### **Board or Commission: Conservation Commission**

**Date and Time of Meeting: Wednesday August 19, 2020 at 7.00 P. M**

Conservation Commission Meeting

Meeting Minutes

SITE DEVELOPMENT & FACILITIES PLAN

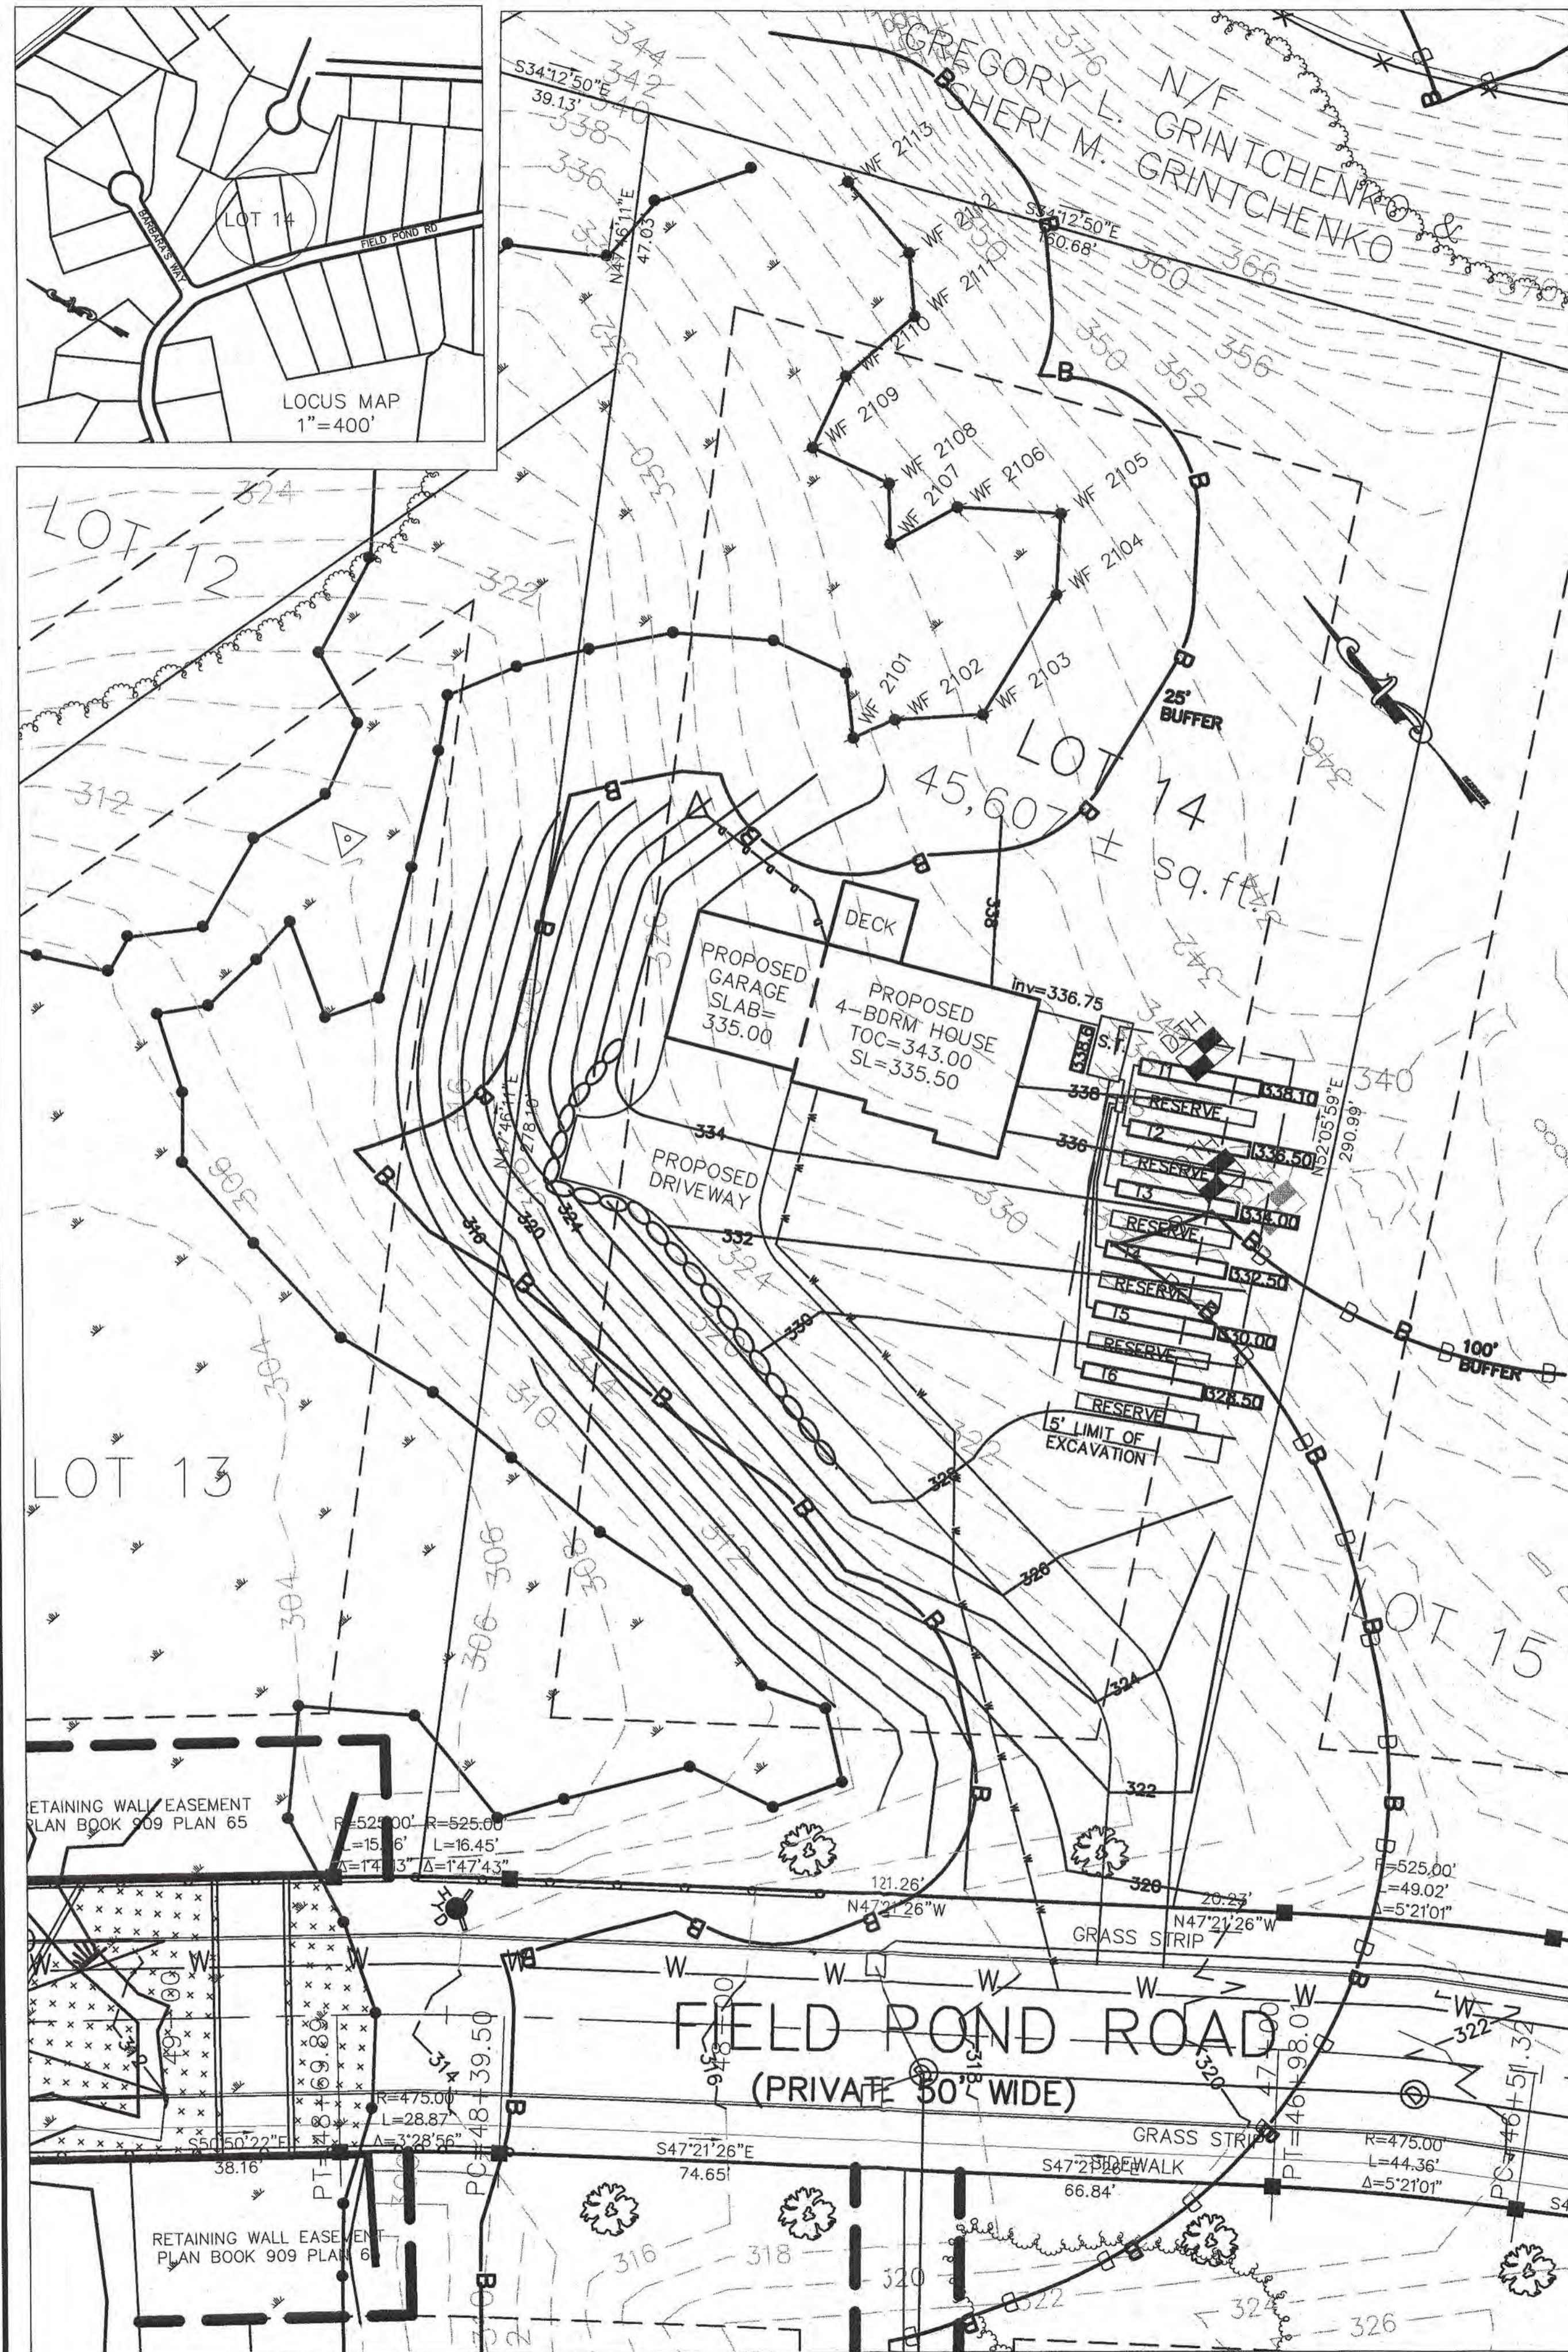
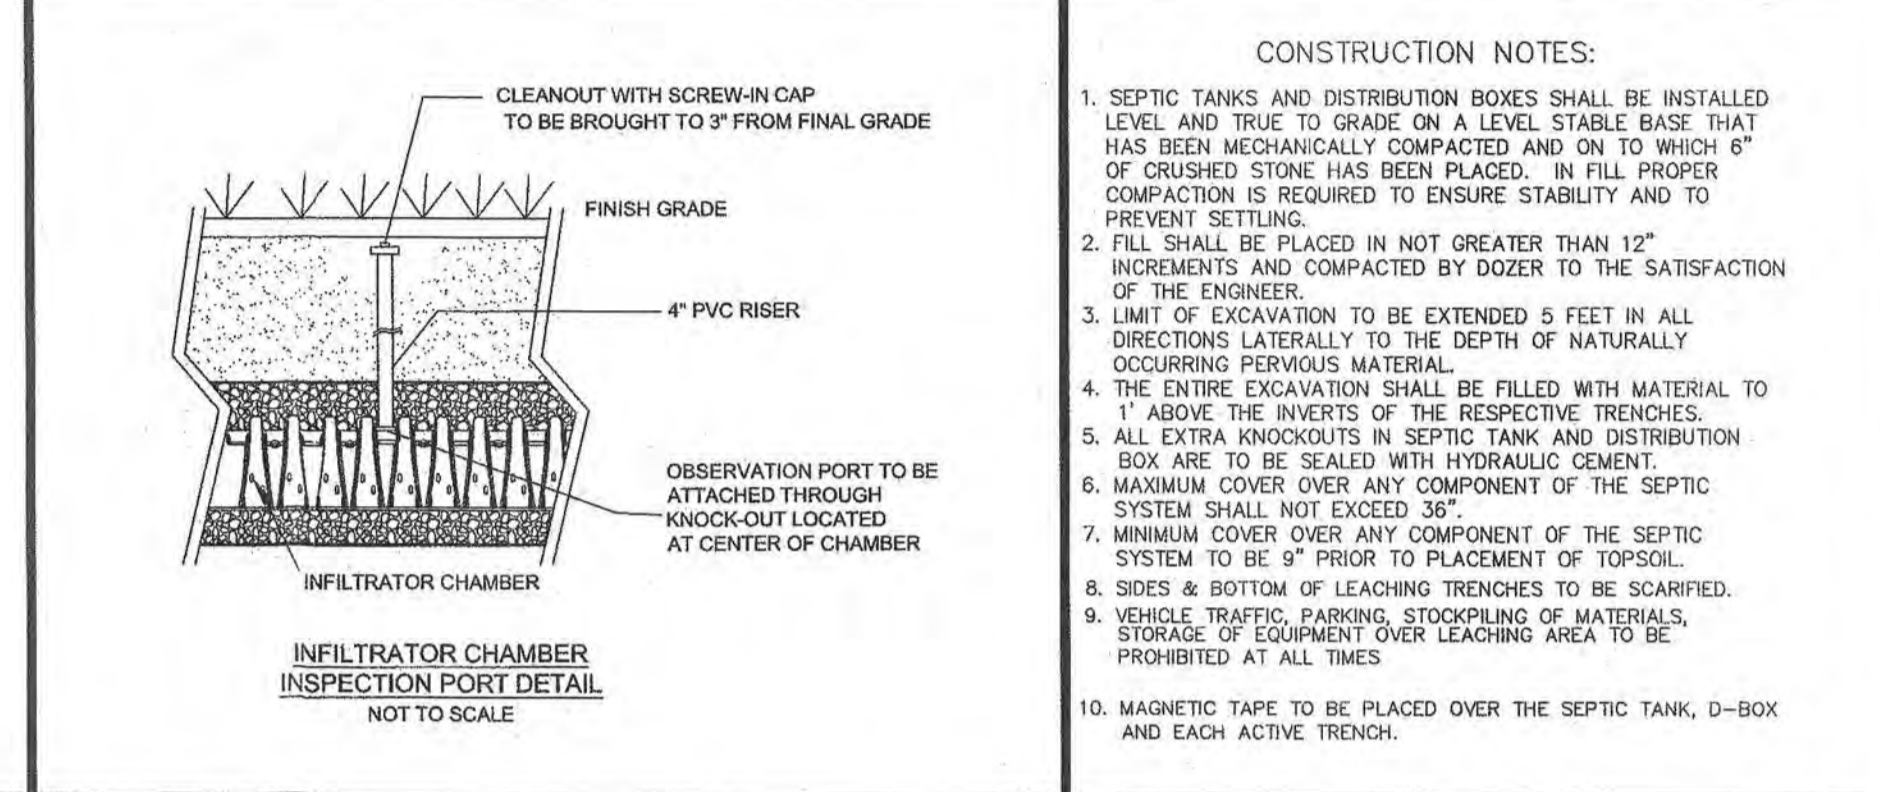
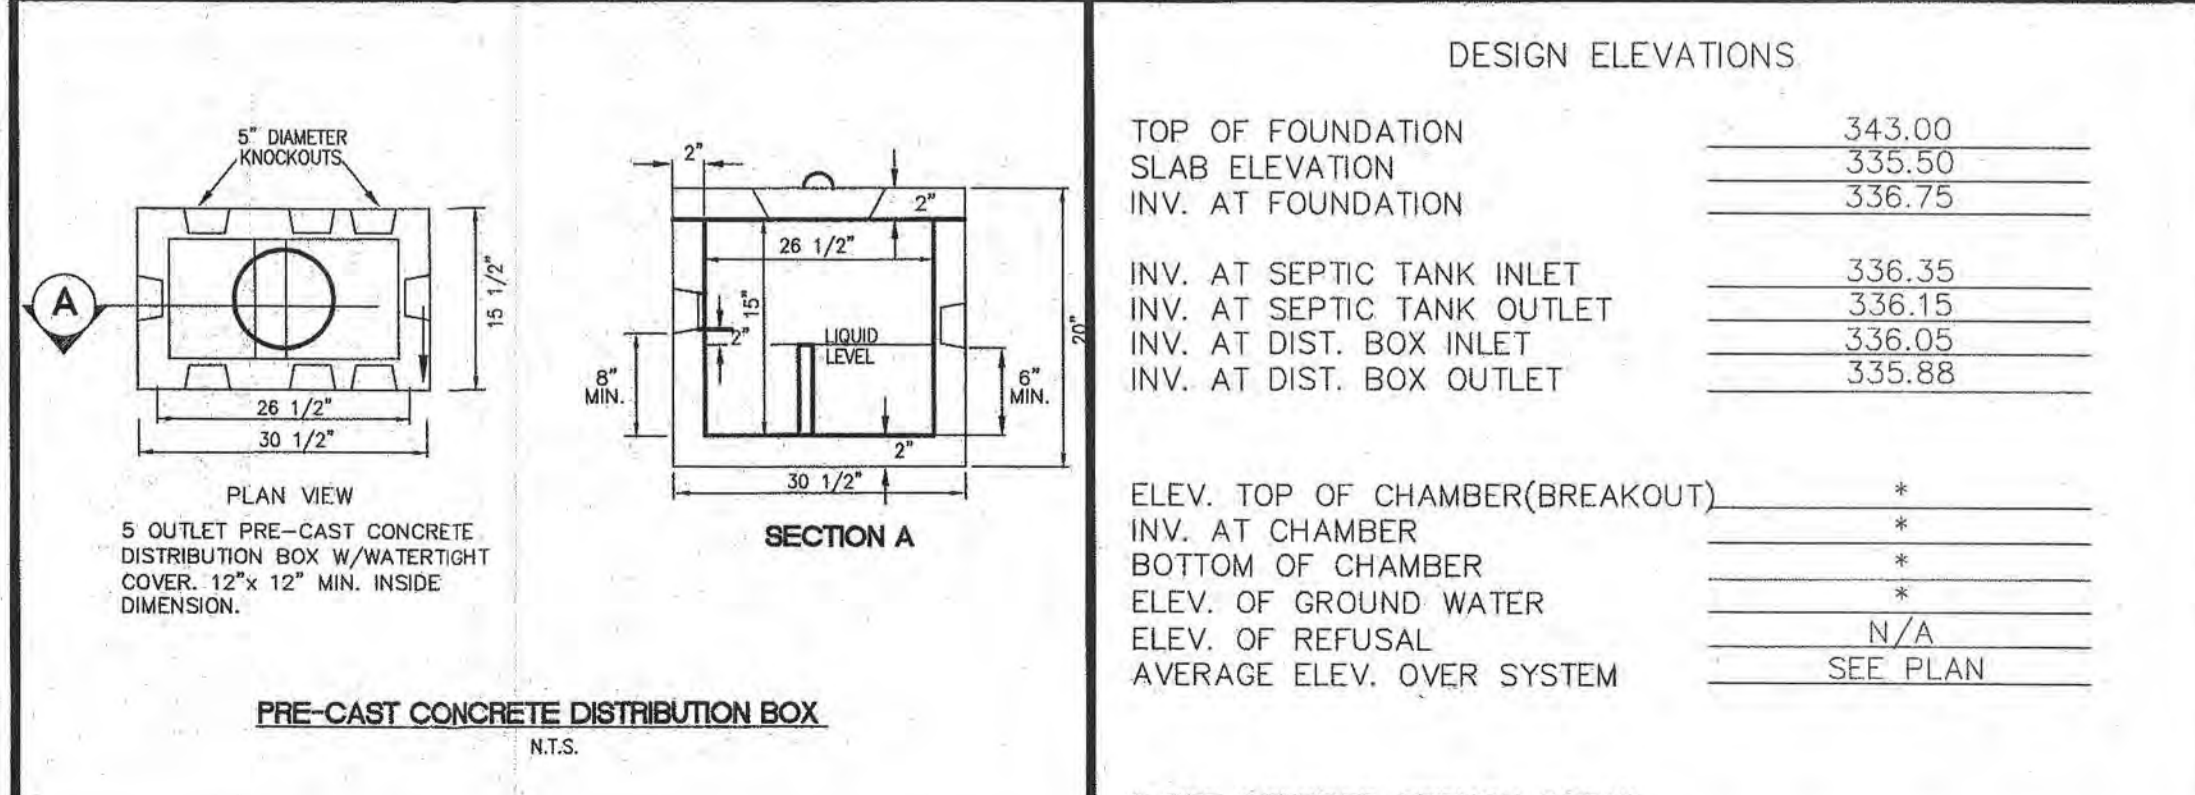
1. The trees have already been cleared, must have been due to an oversight. All the work is in the 100-foot Buffer Zone of the BVW, there is no alteration of the Resource Areas. The closest distance from the proposed activity to the edge of the wetlands is approximately 5-feet +/-.
2. Erosion control measures should be shown on the plan.
3. The wetland flag numbers are shown on some of the flags, but not all of the flags. The remaining wetland flag numbers should be added to the plan.

I recommend that the above items be added to the plan and then issue an Order of Conditions.
